**Re; Planning Reference Number: SD22A/0436**

Site Address: 64 Monastery Drive, Clondalkin, Dublin 22, D22EW65.

**Subject: Request for Additional Information Issued on 18 January 2023**

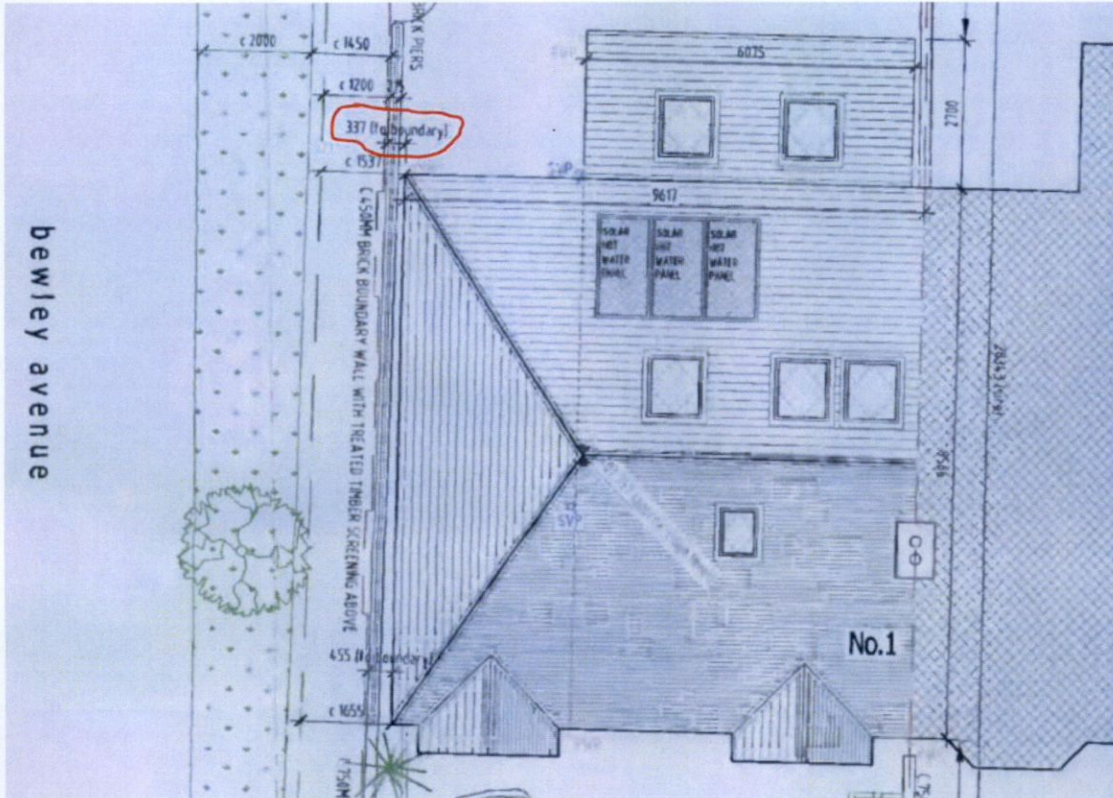
1. The dwelling is proposed to be built on the southern boundary with no setback provided. The applicant is required to:
  1. Provide a minimum set back of 0.9m or the minimum required by water services following the inclusion of appropriate separation distance for water infrastructure on the southern boundary wall of the site.

The revised site plan, floor plans, elevations and sections show the adjustments made to the proposed house design.

A minimum setback required by Irish Water has been verified by Irish Water in their approval of the original layout. Irrespective, a setback of 900mm has been designed in at ground level.

The side projection has been removed and the rear extension narrowed. An angled wall at ground floor level joins the main house to the rear extension. At ground floor level this creates an average setback greater than 900mm with Southern Boundary and allows for a side access to the garden.

At first floor level the footprint to the rear has not been adjusted, creating an overhang in the southeast corner. The average setback from the southern boundary at first floor level is 750mm.

The intention is to minimise the changes to the aesthetics of the proposed house from the design initially submitted to maintain the integrity of the design. The room layout has been minimally affected and our client's keen wish is to retain the 3-bedroom format at first floor level. A revised table of areas is included below.

Excerpt from Proposed Site Plan, 1 Bewley Drive, Lucan, Planning Ref.: SD11B/0204

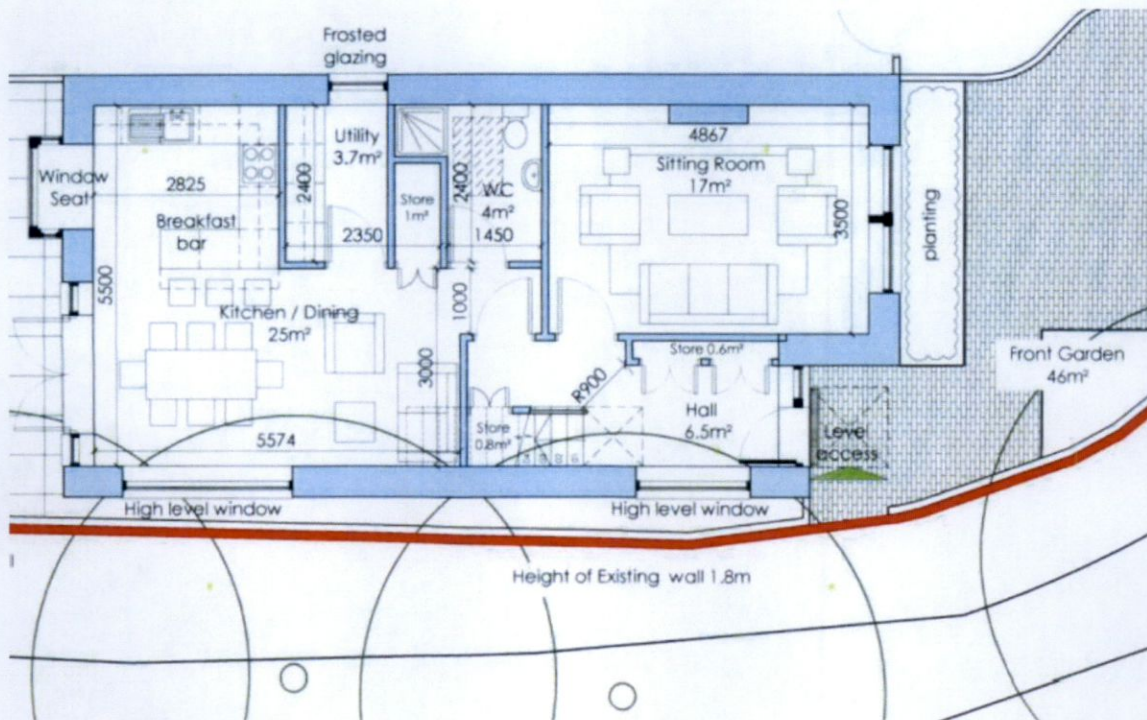
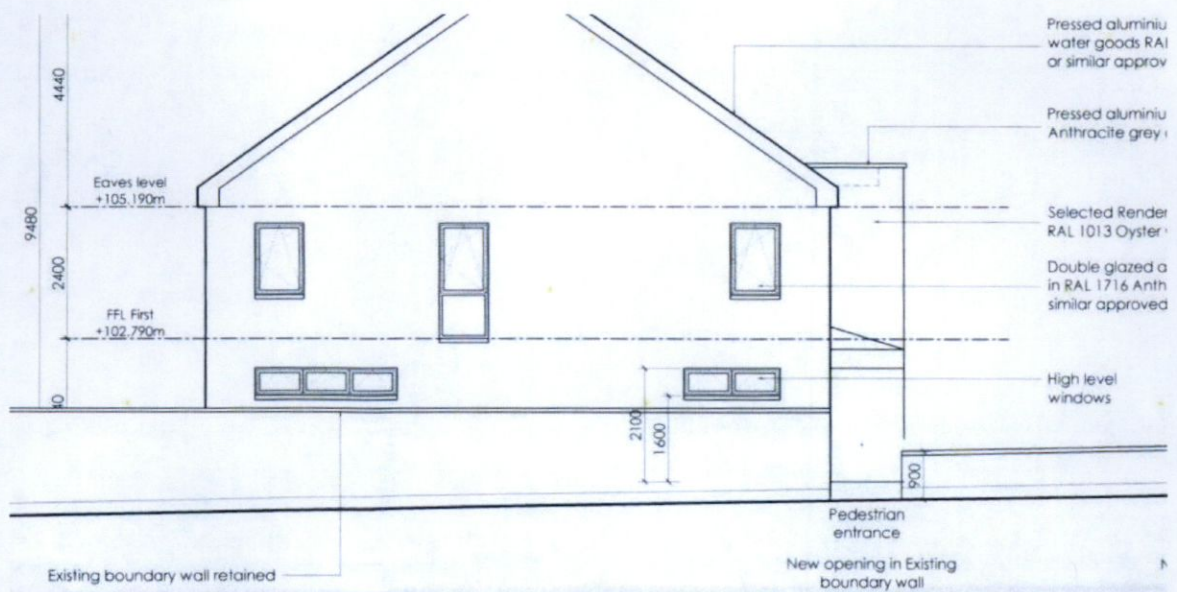
In relation to the first floor setback; we suggest that an average set back at first floor level of 750mm rather than 900mm is still sufficient and is more than consistent with many previous planning permissions granted by SDCC.

We note that in several previous instances in South Dublin Co Council permission has been granted for 2-storey houses that are sited much closer than 900mm to the external site boundary or even directly on the site boundary. Some of examples of this are included pictorially below.
